**Report to** Planning applications committee

**Subject** Application no 19/01702/F - 47 Connaught Road,  
Norwich, NR2 3BP

Development proposal		
Single storey rear extension.		
Representations		
Object	Comment	Support
2	0	0

Main issues	Key considerations
1 Residential Amenity	The impact of the proposals on neighbouring properties; loss of light & outlook.
<b>Expiry date</b>	17 February 2020
<b>Recommendation</b>	Approve

Title  
PROPOSED FLOOR PLANS

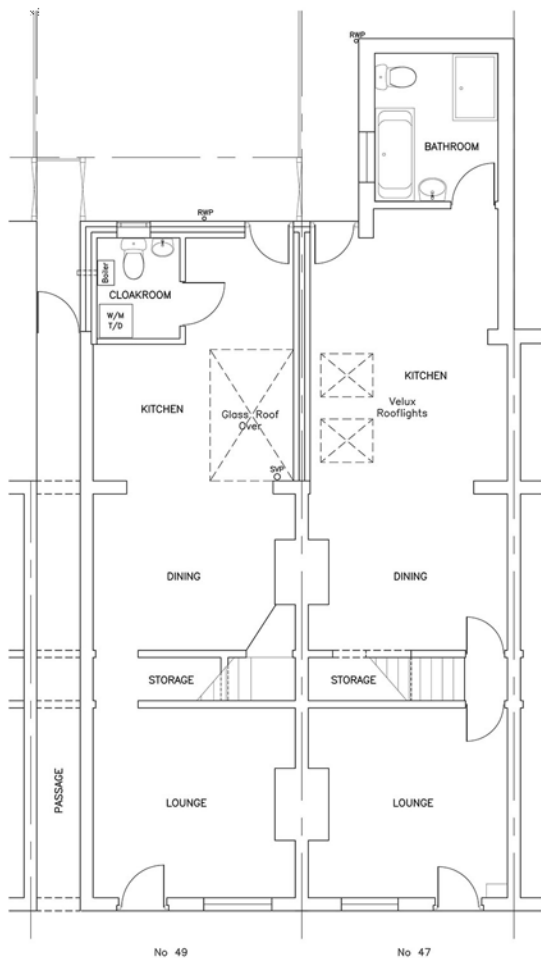
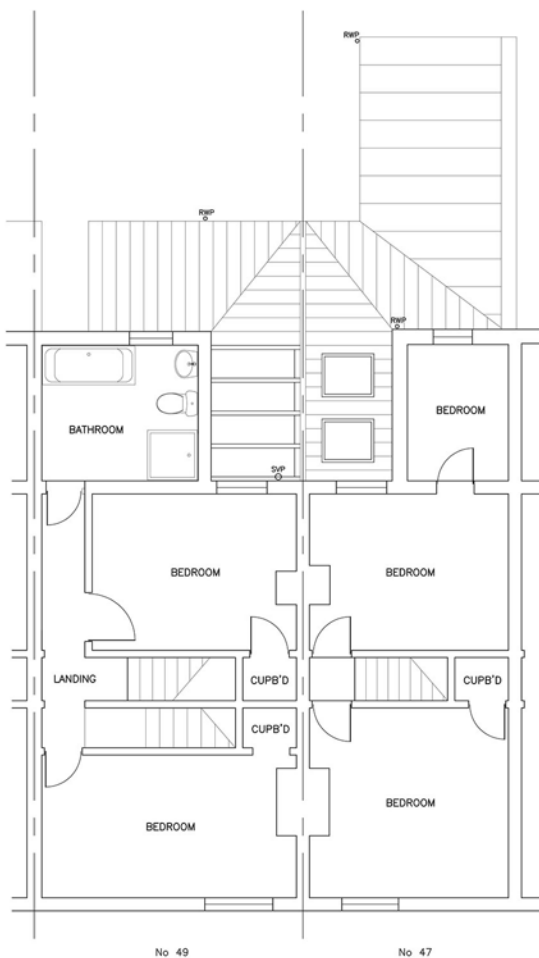
- a) Existing flat roof on rear extension (5.5m in length) replaced with a side-facing mono-pitch roof and parapet wall. On the boundary with no.45, this will raise the height of the roof by 0.8m.
- b) Side-facing glass roof (originally proposed to match the next door conservatory) replaced with tiled roof and rooflights.

20. There are no amenity implications relating to the change of the side facing pitch from glass to tile/rooflight (paragraph 8b).

PROPOSED ELEVATIONS

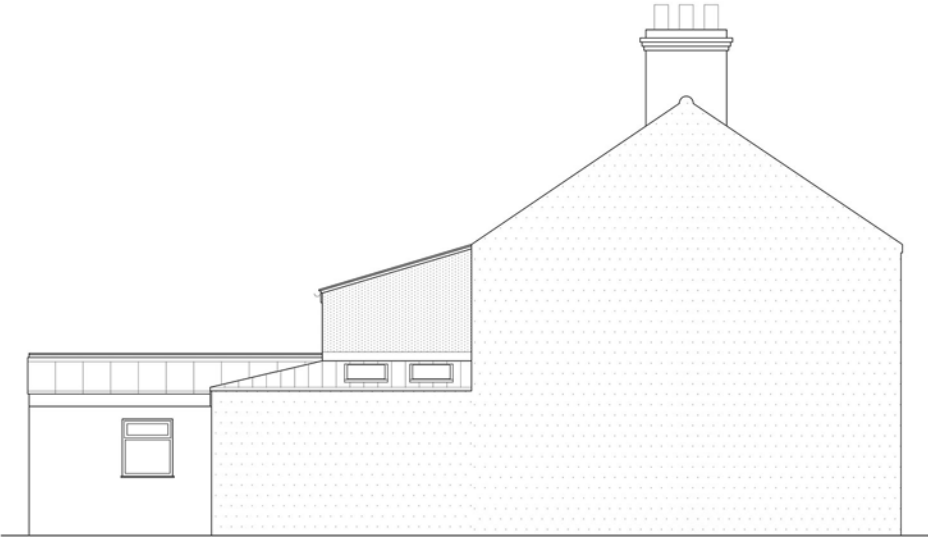
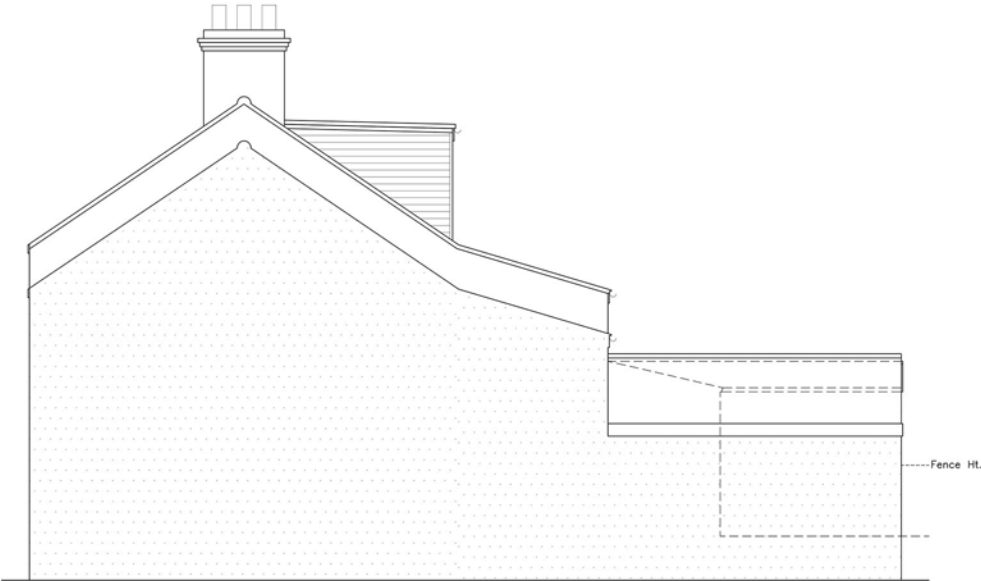
14. Key policies and NPPF paragraphs – DM2, NPPF paragraph 127.
15. As the former plans for the extension have been approved, the assessment below principally focuses on the proposed amendments. The main issue for consideration relates to loss of outlook and increased overshadowing for the box room window of the neighbouring property by the raising and replacing of the flat roof with a pitch roof (paragraph 8a).

16. With the former approved plans the rear-facing pitch roof did raise the current height of the roof, where it meets the existing house and close to the box room window, by 0.6m. With the amended plans this is raised to 0.8m and, as the newly proposed roof pitches to the side, there is now no reduction in height toward the rear. The parapet along the boundary will be roughly level with the top of the glazing in the neighbouring box room window, which is positioned 0.75m from the boundary.

17. The raised roof/wall is directly to the south of the neighbouring window and property. This means that the sun will be at a relatively high trajectory when shining from the direction of the roof. The window will get some light all year, and this will vary from winter months, when just the top of the window will still get some sunlight, to summer months when the window will be scarcely affected. When considering that, for ground floor extensions, it is very common for eaves on the boundary to be notably higher than the top of a neighbouring window, with a greater degree of overshadowing than would be experienced here, the impact in this case will be at a level which can be considered acceptable.

18. In terms of loss of outlook, while most of the immediate view to the left side of the window will be blocked, the window is set 0.75m distant from the boundary and available view of the sky and surrounds, along with levels of diffuse daylight, will still be well within acceptable levels.

21. In conclusion, though there will be some loss of light and outlook to the neighbouring box room window, this impact is not considered to be significant enough to warrant objection and the proposals are acceptable in terms of amenity.

27. Though there will be some impact on neighbouring amenity in terms of loss of light and outlook, this is not considered to be significant enough to warrant refusal. With no other material concerns, the amended proposals are acceptable.
